SUBJECT:  
FORWARDING APPLICANT'S PROPOSED PERMANENT SOLUTION TO SMALL BREAK LOCA FOR  
UNITS 1 & 2 INVOLVING MODIFICATION TO THE HIGH PRESSURE INJECTION SYSTEM.

PLANT NAME: THREE MILE ISLAND - UNIT 1  
THREE MILE ISLAND -- UNIT 2

Three Mile Island Nuclear Station  
TMI-1 DPR-50, Docket No. 50-289  
TMI-2 DPR-73, Docket No. 50-320

ROPOSED PERMANENT SOLUTION  
SMALL BREAK LOCA CONCERN  
(Applicable to TMI-1 and TMI-2)

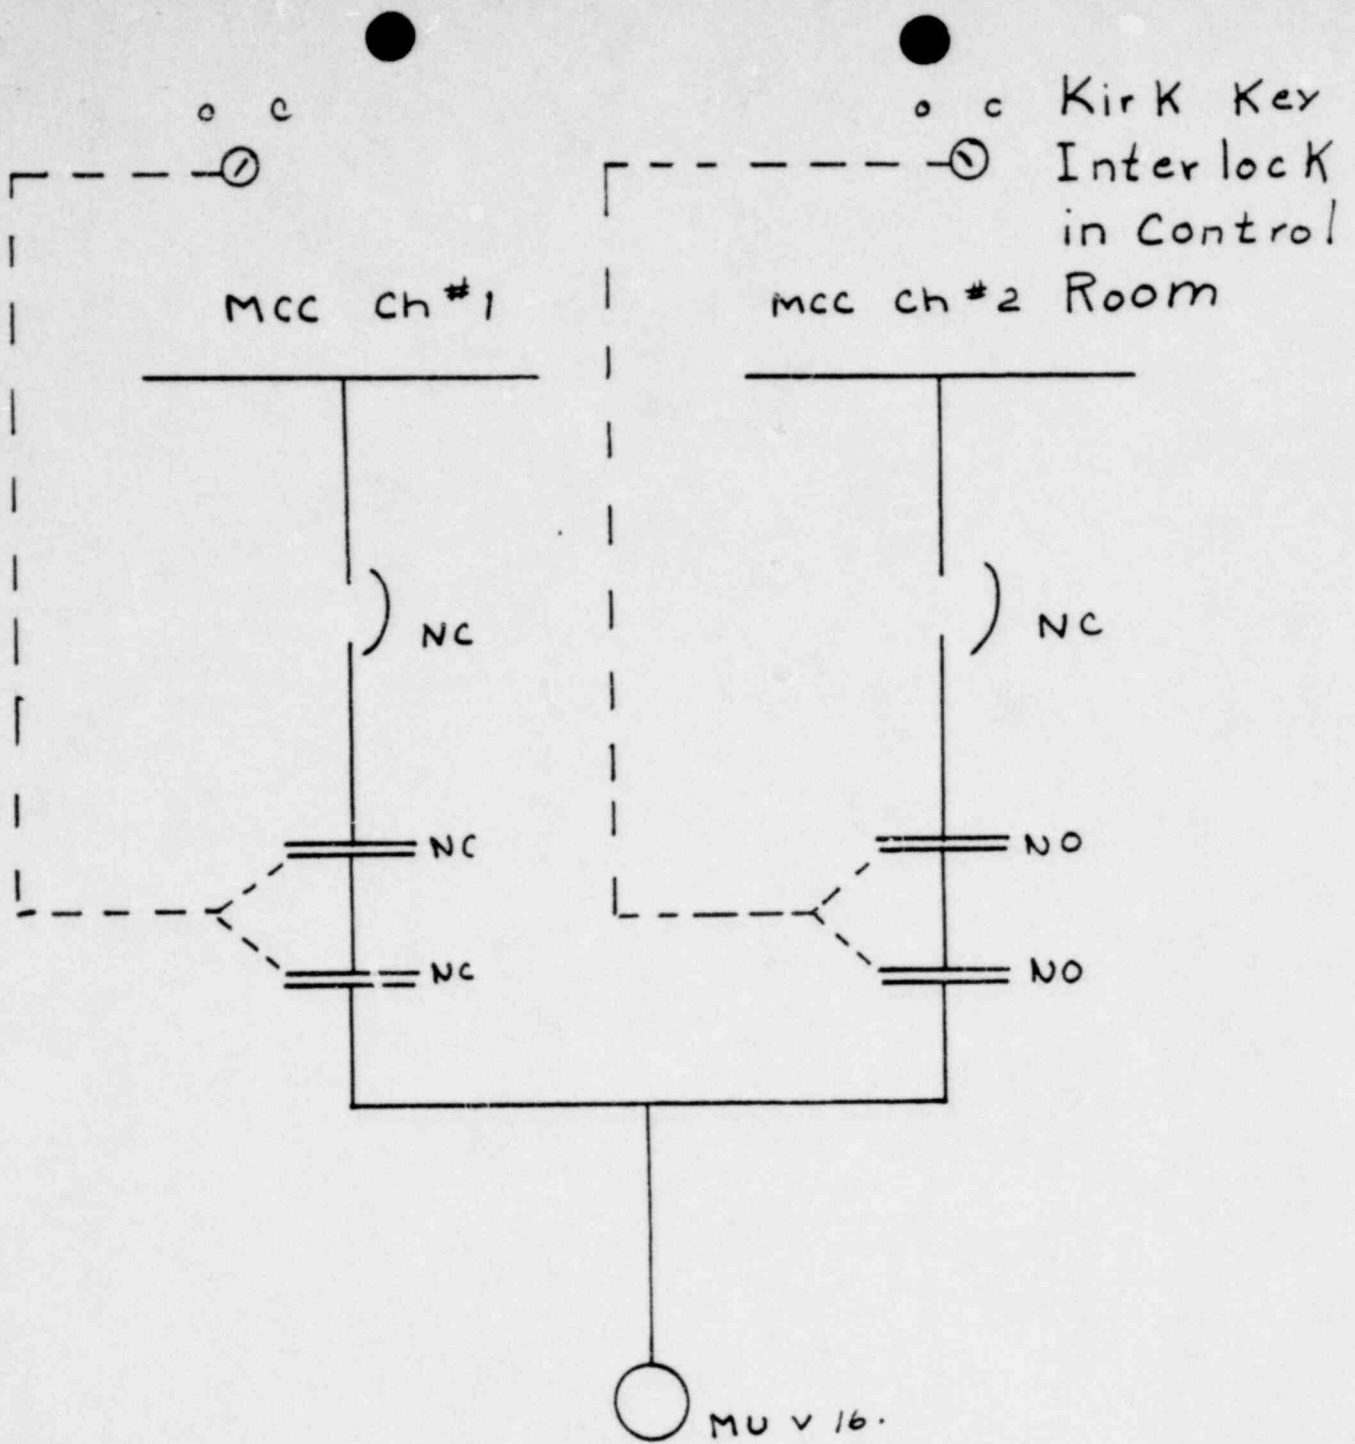
As outlined in the attached sketch, the proposed HPI System modifications will allow each HPI isolation valve to be connected to both the red and green (Channel 1 and 2) power. Each channel will contain redundant contactors between the breakers at the motor control center, and the valve itself. The contactors on Channel 1 will be interlocked by a Kirk Key Interlock in the Control Room, with the contactors on Channel 2. This interlock will preclude closing the contactors on both channels at the same time, and will provide at least two (2) points of separation between the two channels at all times.

Should the postulated Small Break LOCA occur, the operator will receive a safety injection alarm in the Control Room within sixty (60) seconds of the break occurring. Our procedures will (if this proposal is approved), require the operator to, upon receipt of the alarm, verify flow through all four (4) safety injection valves. If the operator identifies "no flow" in any of the injection legs, he will proceed to manually transfer power (using the Kirk Key Interlock) to the valve(s) with "no flow" indication. This will assure flow through all four (4) injection legs, thus meeting the acceptance criteria to alleviate the postulated Small Break LOCA.
